December 23, 1992
LD-92-123

Docket No. 52-002

Subject: Closure of System 80+™ Draft Safety Evaluation Report Issues

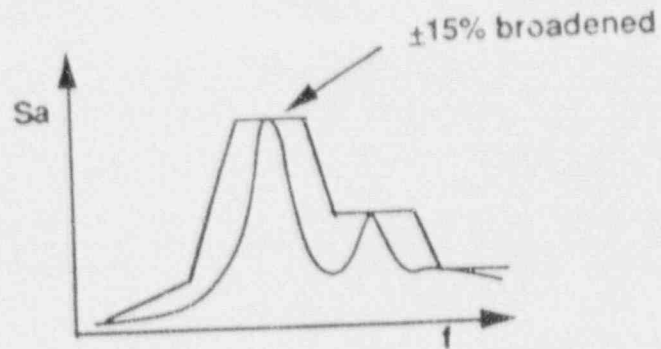
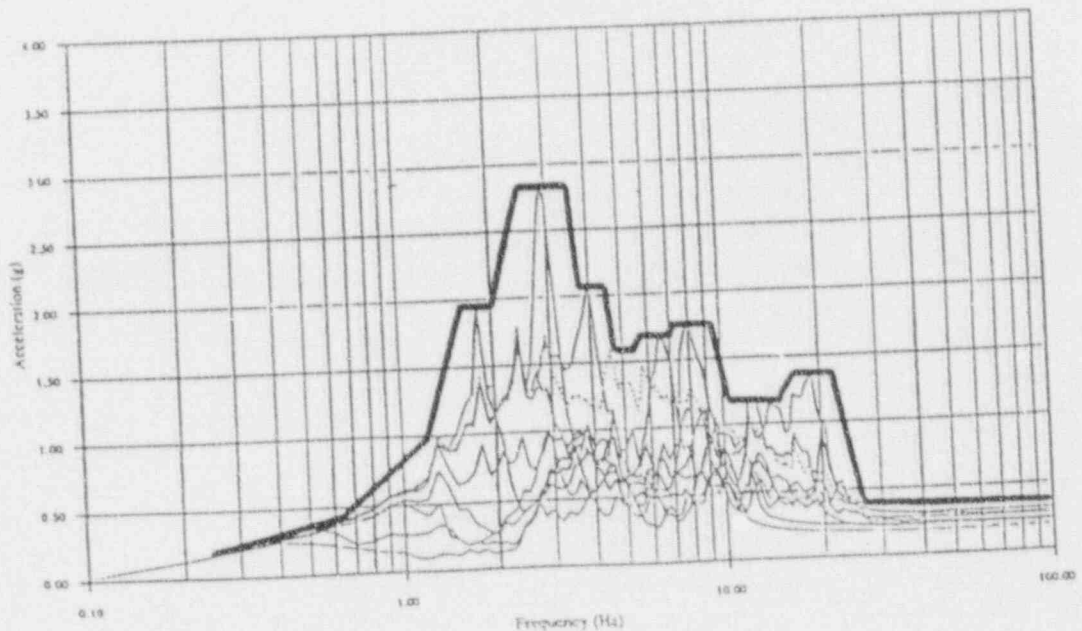
The applicant should use envelope response spectra for design analysis of seismic Category I structures.

The envelope of floor shears, axial forces and moments from all soil cases will be used to design the Category I structures (except of the Steel Containment Vessel). The shears, axial forces and moments will be applied statically to a detailed model of each structure in order to obtain local stresses for the design of all walls, columns, beams, slabs and other structural elements.

Because the Steel Containment Vessel was modeled in the seismic SSI analyses with a simpler model (compared to the finite element model which is used for its detailed design), a special procedure will be followed to compute the stresses on the SCV due to the seismic loads. A dynamic analysis of the detailed finite element model will be performed using $\pm 15\%$ broadened spectra (translational and rotational) corresponding to elevation +91.75 of Interior Structure (SCV support location) for all the governing cases.

The design of the System 80+ piping and in-structure components will be performed using one of the three options presented below.

This is the first option that will be used in the design process. According to this option, broadening of the raw response spectra by $\pm 15\%$ will be initially performed for all soil cases. The envelope of the broadened spectra of all soil cases will then be directly used in the design. The objective is to exercise this option for as many of the piping and components as possible. However, it is recognized that excessive conservatism may be introduced in the design of some piping or components, in which case Options 2 or 3 will be applied.

Figure 3.7.1-1.1 - Comparison between CMS1 and CMS2 vertical rock spectra (7% Damping)

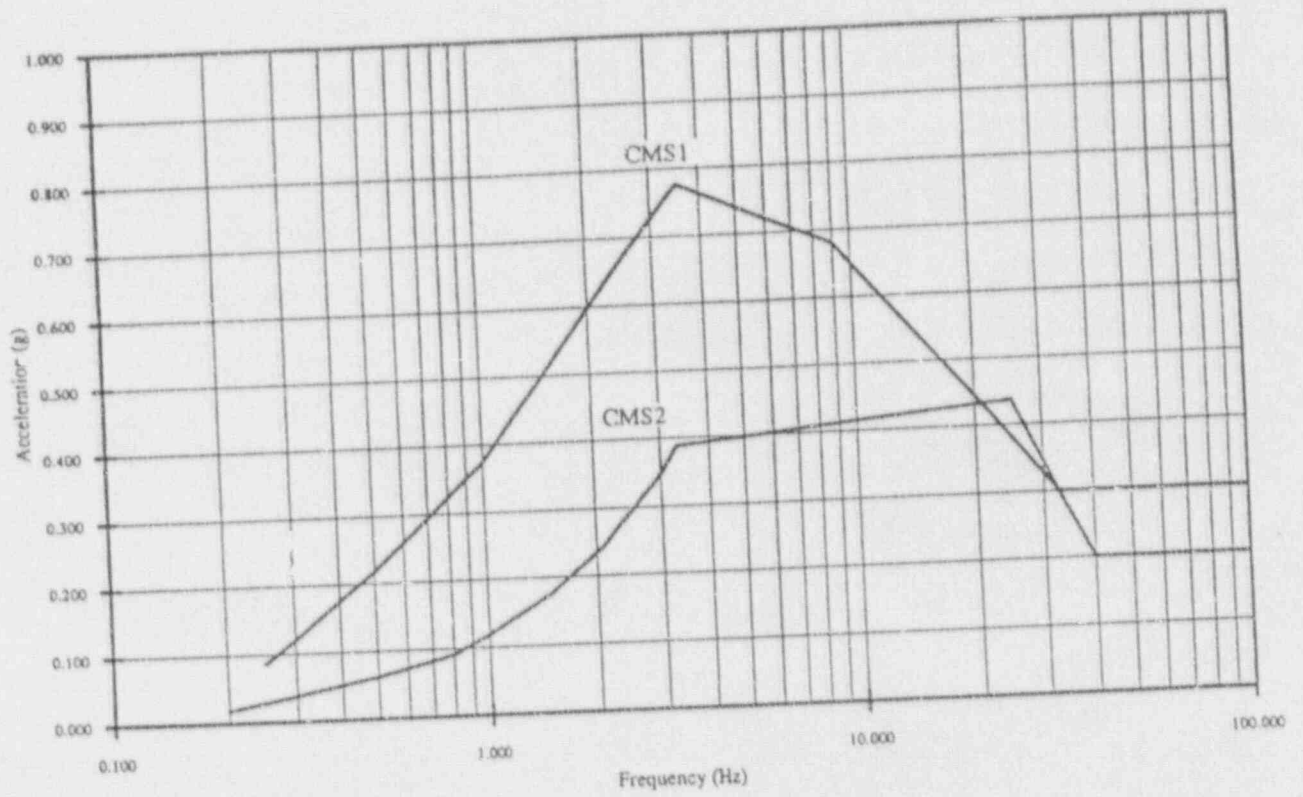
In addition, the CMS1 vertical motion (0.3g PGA) envelops the CMS2 vertical rock outcrop motion (0.2g PGA) at almost all frequencies, as shown in the attached Figure 3.7.1-1.1.

Based on the above, it is judged that, although the CMS2 vertical spectra strictly do not meet the SRP 3.7.1 criteria for 7% damping, the analysis results are not affected.
